### 3/4.2 POWER DISTRIBUTION LIMITS

#### LINEAR HEAT RATE

8510230022 851018  
PDR ADDCK 05000335  
P PDR

FIGURE 3.2-1 ALLOWABLE PEAK LINEAR HEAT RATE VERSUS FRACTION OF CORE HEIGHT

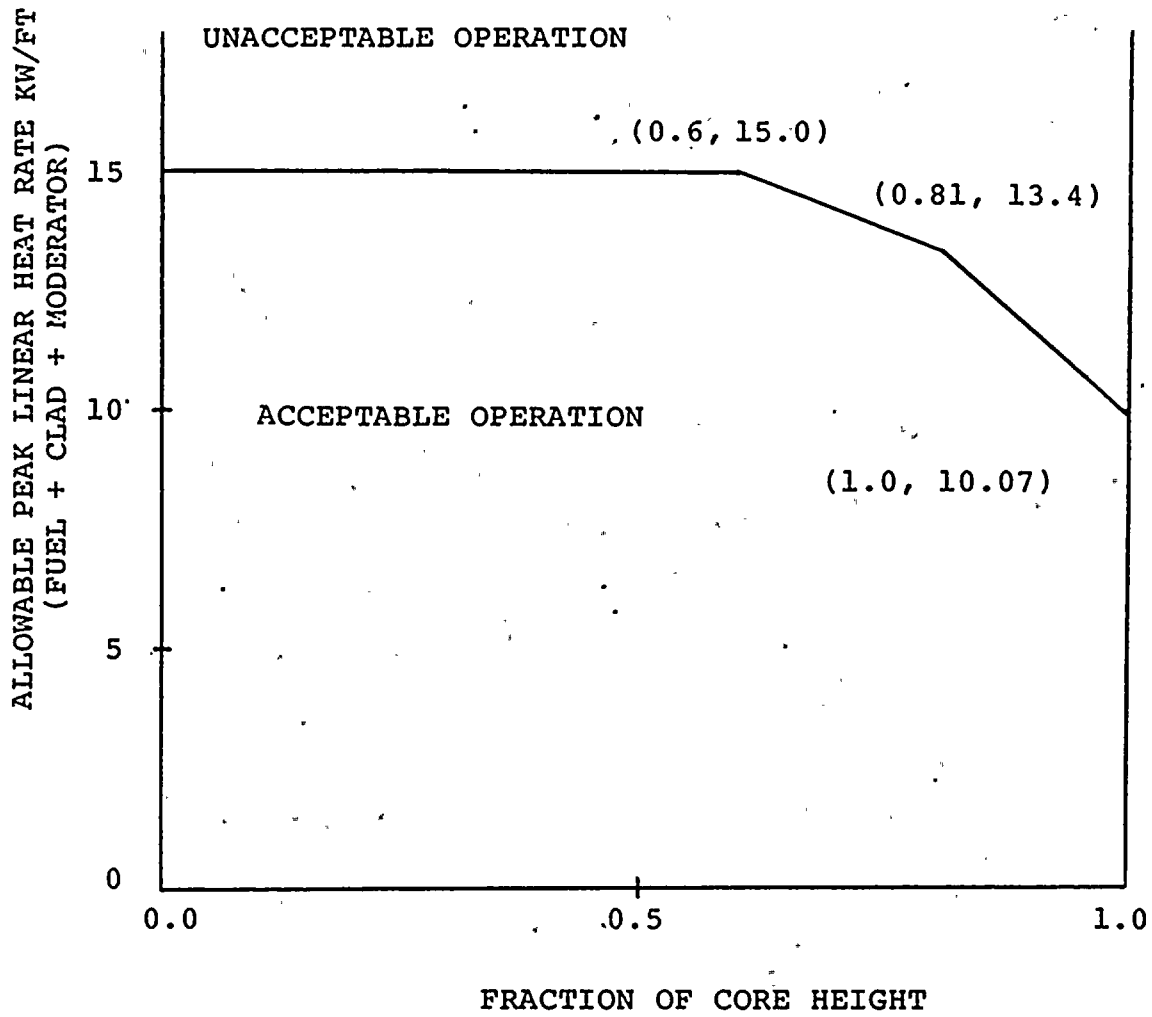
- a. Are adjusted to satisfy the requirements of the core power distribution map which shall be updated at least once per 31 days of accumulated operation in MODE 1.
  - b. Have their alarm setpoint adjusted to less than or equal to the limits shown on Figure 3.2-1 when the following factors are appropriately included in the setting of these alarms:
    1. A measurement-calculational uncertainty factor of 1.07,
    2. An engineering uncertainty factor of 1.03,
    - ~~3. A linear heat rate uncertainty factor of 1.01 due to axial fuel densification and thermal expansion, and~~
- 3A.** A THERMAL POWER measurement uncertainty factor of 1.02.
